**RE: SECTION 4.55(2) MODIFICATION TO DEVELOPMENT APPLICATION
DA-422/201821
684-700 CANTERBURY ROAD, BELMORE**

This Section 4.55(2) application seeks to extend the approved lift to access the communal open space at roof level; to provide solar panels and minor changes to the internal planning of two (2) units.

Figure 2: LEP Height Blanket (Drawing No. DA 7035)

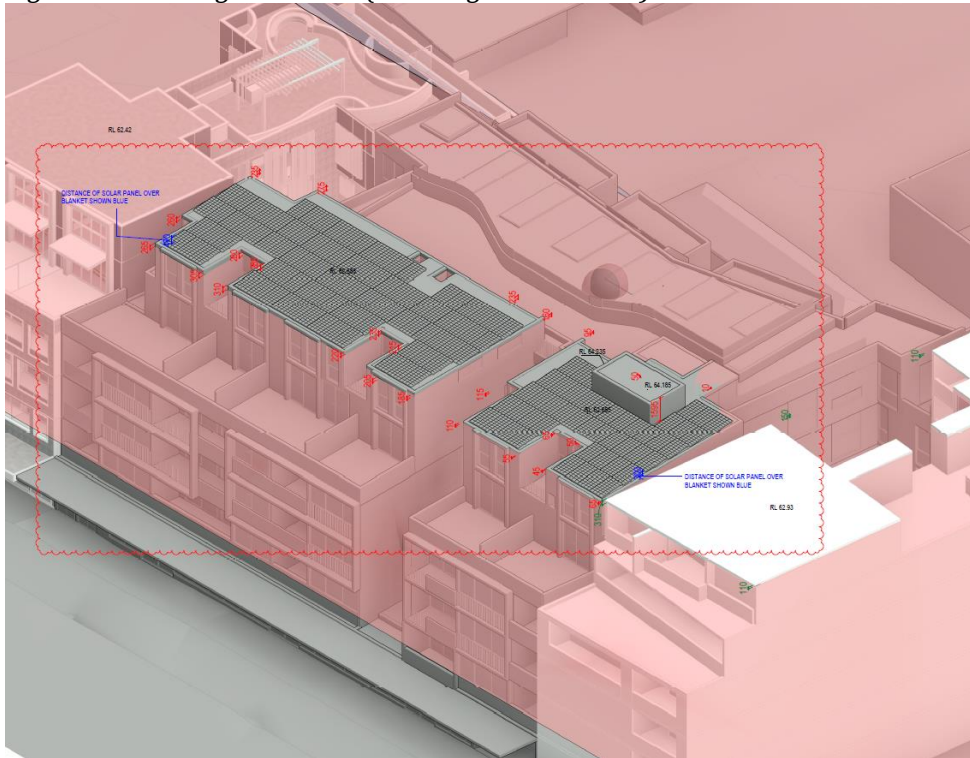
The lift overrun to facilitate this access is the new highest element proposed at a height of 19.620m, a variation of 1.620m. A variation is also sought for the enclosed lift lobby (18.065m) and the solar panels (18.255m – 18.470m).

The variations are depicted in the sections and height blanket as indicated in Figures 2 and 3 below.
